ISLANDS PLANNING COMMISSION STAFF REPORT

Meeting Date: July 21, 2020

Application Type	Village Preservation
Case Number	VP4300
Applicant	James A. Bishop, agent, for Sandy Vacation, LLC, owner
Property Address	513 Beachview Drive, 315 15 th Street, 108, 118, 124, 130, and 140 Pier Village Market, 300, 308, and 310 Mallery Street, and 508 Oglethorpe Avenue, St. Simons Island
Parcel ID	04-04653, 04-04652, 04-10230, 04-11659, 04-07017
Area of Property	0.55 acre (combined lots)
Existing Zoning	Village Mixed Use (VMU) and Island Preservation Design Review District (IP) and the applicant is proposing to rezone it to Planned Development District (PD) (case number ZM4299) and Island Preservation Design Review District (IP)
Existing Land Use	Commercial (retail and office) and Residential
Proposed Zoning	Planned Development District (PD) and Island Preservation District (IP)
Proposed Land Use	Art Museum

NARRATIVE: ST. SIMONS ART MUSEUM

PLAN TITLE:
Tree Protection Plan

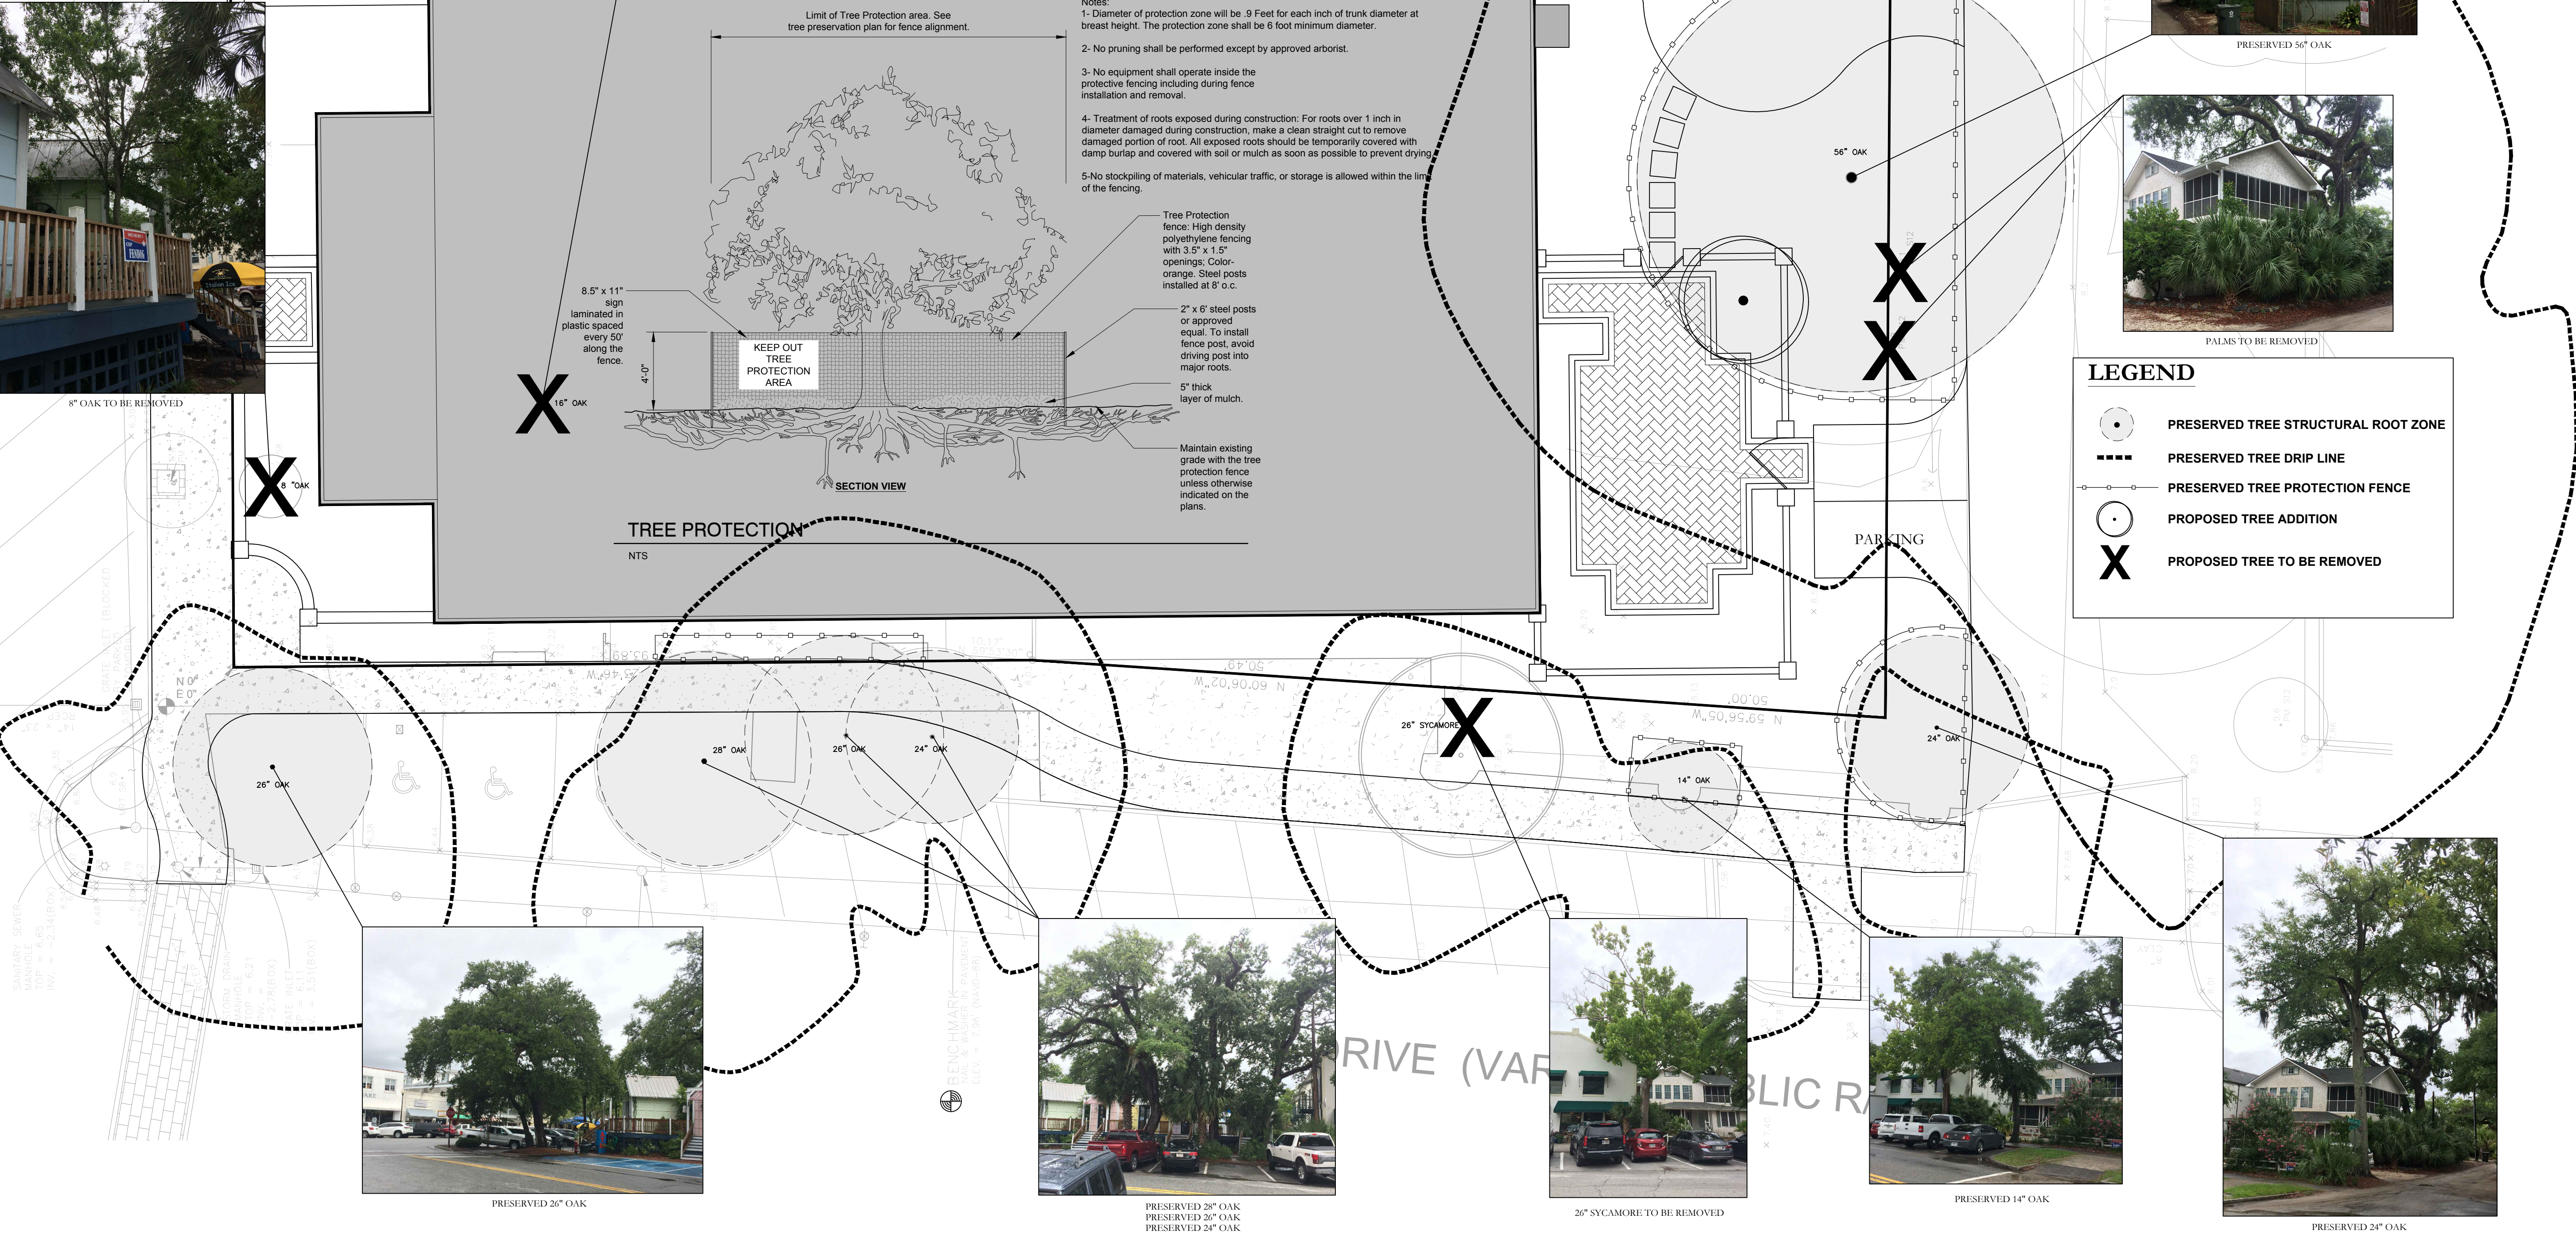
22805 Planning and Zoning NC in order to input resubmittal.	1	Leif	Compliant	Keller	03/18/2020
22972 Planning and Zoning	2	Leif	Compliant	Leif	03/30/2020
22842 Review for the trees 1 - All Plantings and removals within the R/W are prohibited. A special review and approval process is required to allow private use of R/W. The sycamore and 2 unidentified removals on page L1, 3 additional live oaks plantings and any vertical landscape planting as indicated on the drawings that are within the R/W should be included in a single request for review. Coordinate with Glynn Co. Engineering ____ 2 - Reduce planting within the structural root zones of all trees in lieu of mulch surface treatment. Add note that air spade is to be used to excavate all plantings within the structural root zones of retained / preserved trees. 3 - Include open soil calculations for each tree or area of multiple tree plantings. 4 - Will trimming / pruning be required to any preserved tree in order to accommodate proposed construction? If so, identify and include with plan for review and approval. 5 - Include photos of trees to be removed and preserved as explained in section (a)1)c of tree ordinance (section 624.7). 6 - No planting or obstructions between 30" and 10' within 25' of two intersecting R/W's per zoning ordinance 615. 7 - Eliminate one parking space of the three indicated on Fifteenth so that remaining spaces total paving section is located outside of and between the two preserved trees structural root zones	1	Flowers	NOT Compliant	Flowers	03/10/2020

Review	#	Assigned To	Result	Result By	Completed
	(See attached tree review)					
23687	Review for the trees	2	Flowers	Compliant With Comments	Flowers	07/11/2020
	Trees to be preserved are to be marked and an on-site pre-construction meeting is required prior beginning site work of this development to discuss tree preservation and protection details. Once development of this project is underway, the details outlined in this tree plan and those determined and discussed at pre-construction meeting will be strictly enforced and any deviation from the approved tree plan and protection measures stated within will result in an immediate stop work order and further enforcement actions and penalties.					
22806	Traffic	1	Vicent	Not Applicable	Vicent	03/02/2020

Courtyard Wall
The Structural Root Zone according to the County Tree Ordinance Is 0.9 feet per diameter inch at breast height. Air spading a line of demarcation at the alignment of the proposed courtyard wall will allow us to determine the extent of any structural roots. The proposed courtyard wall would be built using a simple grade beam and augured piers to bridge these structural roots.

The proposed building's foundation falls outside the Structural Root Zone for the trees located in the adjacent right-a-way. Air spading a line of demarcation at the foundation edge will allow us to determine the extent of any critical roots. At that point they can be cut cleanly, allowing for potentially 100% regrowth as opposed to the 30-40% expected when roots are torn, ripped and crushed. This line of demarcation guarantees no unqualified damage to the critical root zone.
